**REFERENCE: OWL CREEK RESERVE MINOR RPD
DCI2021-00011
Post Sufficiency Response**

This letter is written in response to the sufficiency letter dated April 14, 2022, which identified the following issues to be addressed during the substantive review prior to hearing.

Subject: **Owl Creek Development – Seagrass Survey Report**

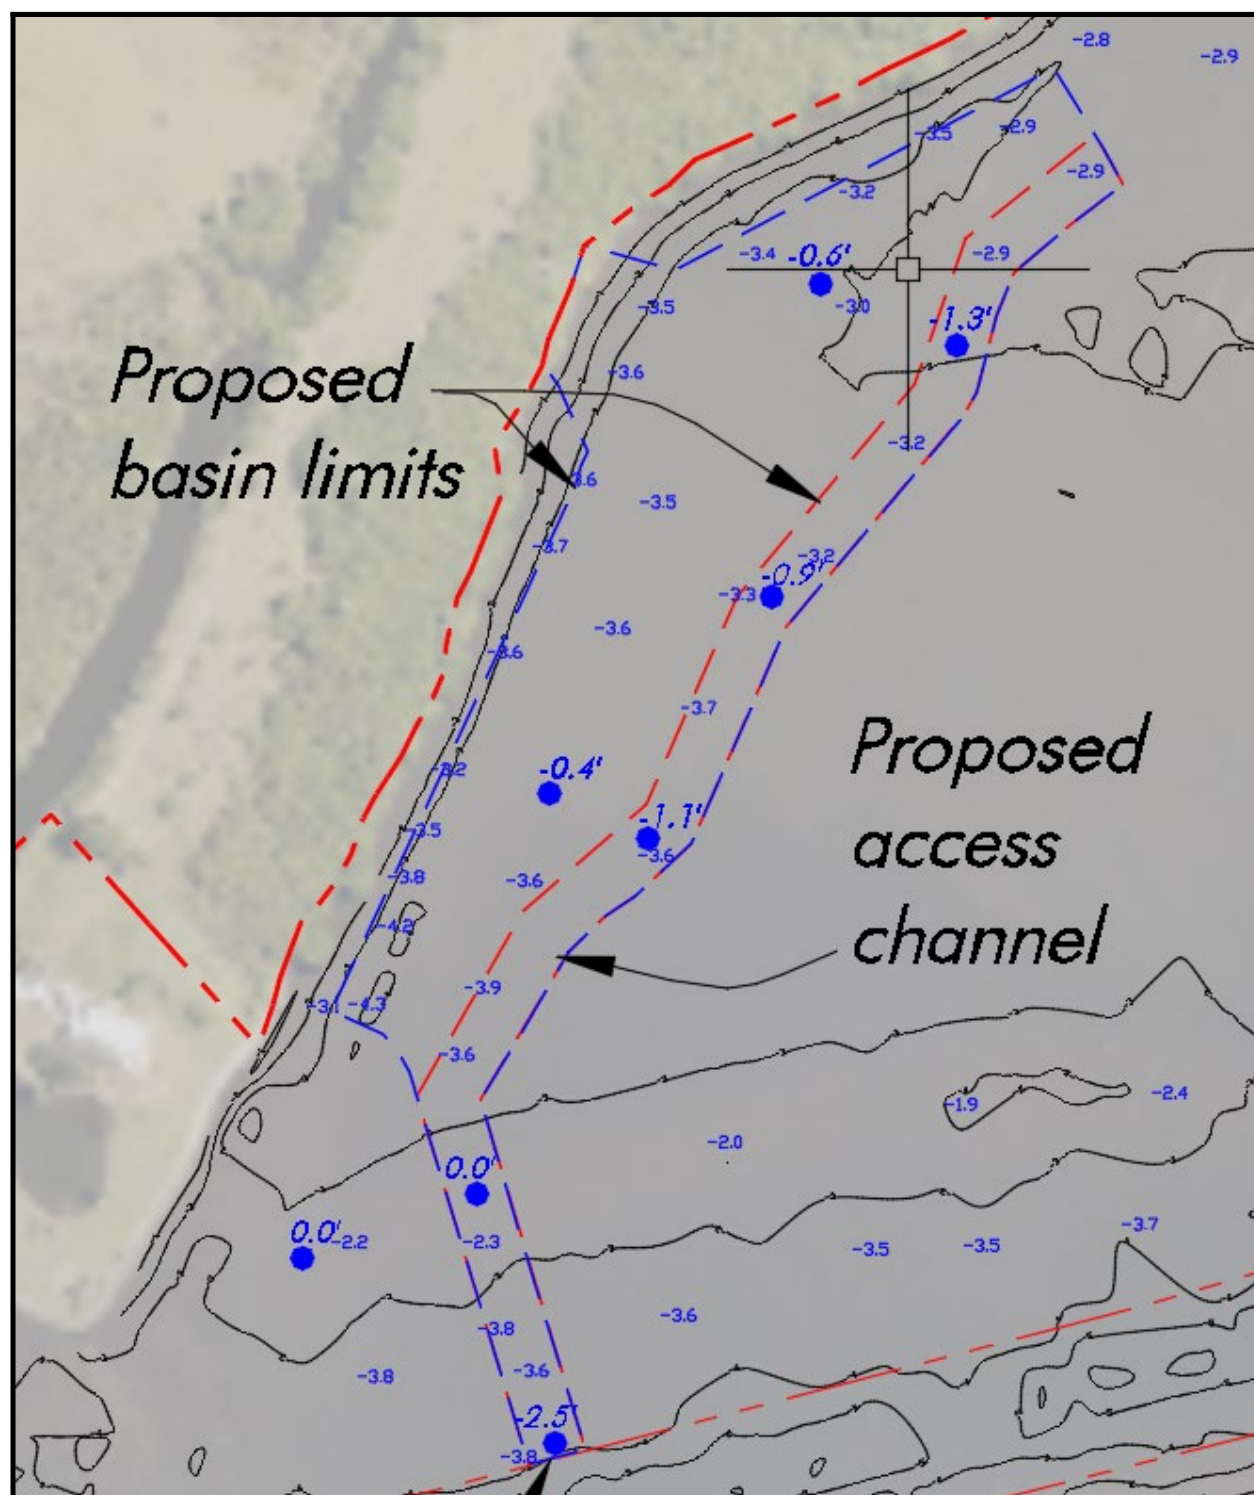
Comment 1: Proposed dredging for the multi-slip docking facility is inconsistent with Lee Plan policy 128.4.8. Policy 128.4.8 states, "Boat access facilities should be located in areas of maximum physical advantage. Adequate existing water depths between the proposed facility and any navigational channel, inlet, or deep water, are preferred, as new dredging is discouraged." This project as designed requires dredging to obtain water depth of -4MLWL. Furthermore, Lee Plan policy 128.4.6 requires that proposed boat access facilities and expansion of existing facilities be evaluated in accordance with Section 8, Marine Facility Siting Requirements, of the Lee County Manatee Protection Plan (MPP). Per Section 8 of the MPP, a facility must first meet success criteria for both seagrass and water depth to qualify for boat slips.

Comment 2: Proposed dredging for the multi-slip docking facility is inconsistent with Policy 128.4.7 states "Boat access facilities, including multi-slip docking facilities and boat ramps which would disturb or destroy wetlands or grassbeds must demonstrate a pressing need for the proposed facility and must provide for continued use by the general public." The project proposes wetland impacts for the use of private multi-slip docking facility.

Please see the updated Bathymetric Survey completed on 5-11-22. The survey shows an existing marked channel that runs north from the river to Owl Creek Boat Works, located on the west side of the subject property. The channel has water depths of -5 and -6 MLW. The proposed multi-slip docking facility and 50' wide access channel will connect to the existing Owl Creek Boat Works channel. Minimal dredging is proposed to avoid unnecessary scour of the bottom from prop wash and to allow the use of the slips and boat slips year round. The dredging also provides sufficient water depth for the long-term use of the private multi-slip docking facility, reducing maintenance dredging frequency and providing better clearance for any potential manatees occupying the site. Although new dredging is discouraged by Policy 128.4.8, it is not prohibited. The proposed location of the private multi-slip docking facility is protected from boat wakes generated by vessels operating in the Caloosahatchee River Water. It is also protected from wind waves and has a very short travel distance to the river.

Above is a close up of the electronic survey, including spot depths from the survey and survey rod readings depicting the silt layer. Each blue dot shows the thickness of the silt. If you deduct the silt layer and refer strictly to hard bottom in almost all locations we are at or deeper than -4' MLW, with the exception of the shallow bar that needs to be crossed to get to the interior waterway. I would tender that this qualifies as the minimal dredging required to secure access to the site.
